## SUBMITTAL TRANSMITAL

August 27, 2012 Submittal No: 08301-003.A

SUBJECT: Submitting Specified Items for Overhead Sectional Doors for the P&D Building

SPEC SECTION: 08301 - Overhead Sectional Doors

Submittal 08301-003.A. OH Door for the Pumping & Disinfection Building – By Clopay

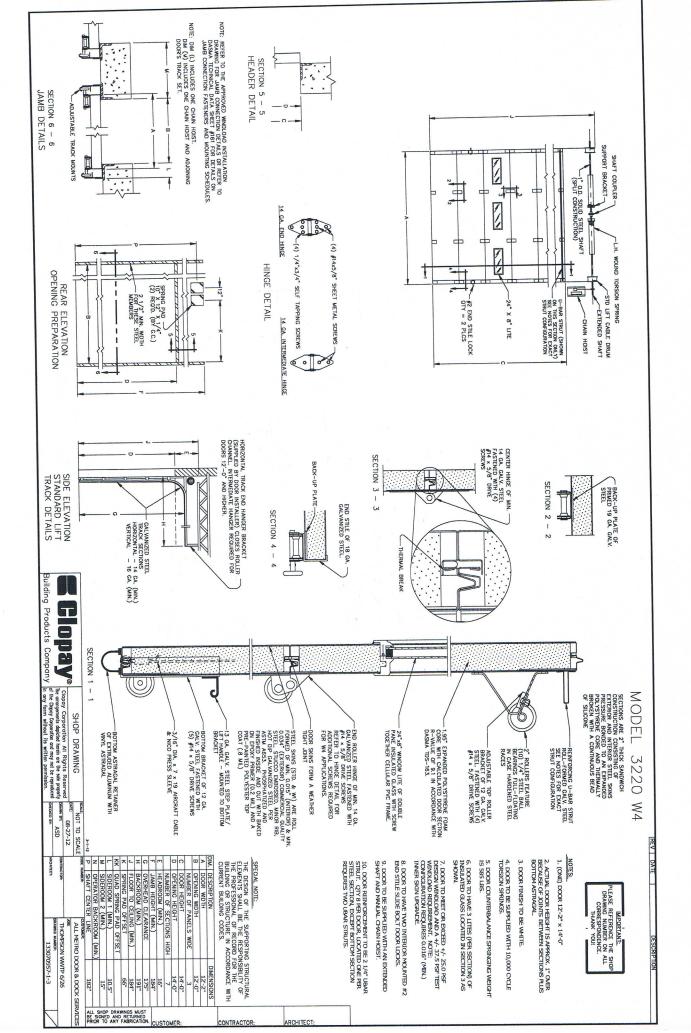
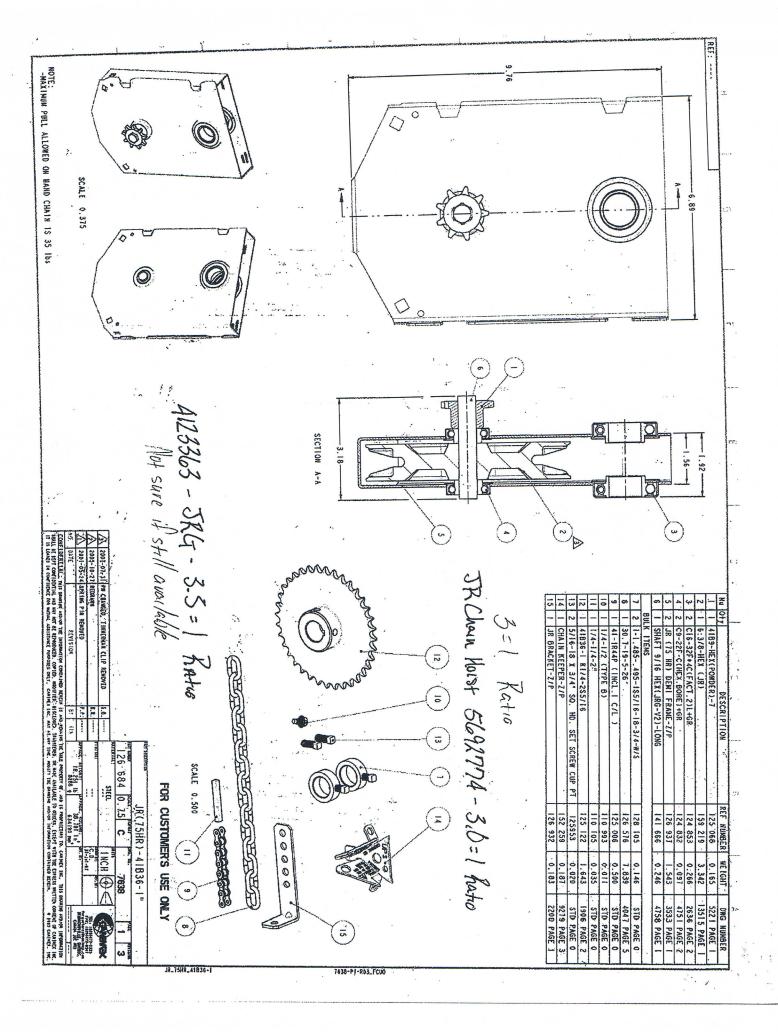
- 1. WCM has reviewed with the supplier the required track height for allowable clearance over the bridge crane will be 175".
- 2. Chain hoist has been added.
- 3. Clopay can meet the 100 mph wind requirement by change the glass lite to 24" x 8" from 24" x 12".

Clopay model 3220 with W4 rating is available with 24" x 8" window lites. The 24" x 12" size windows have not been tested to W4 wind load ratings.
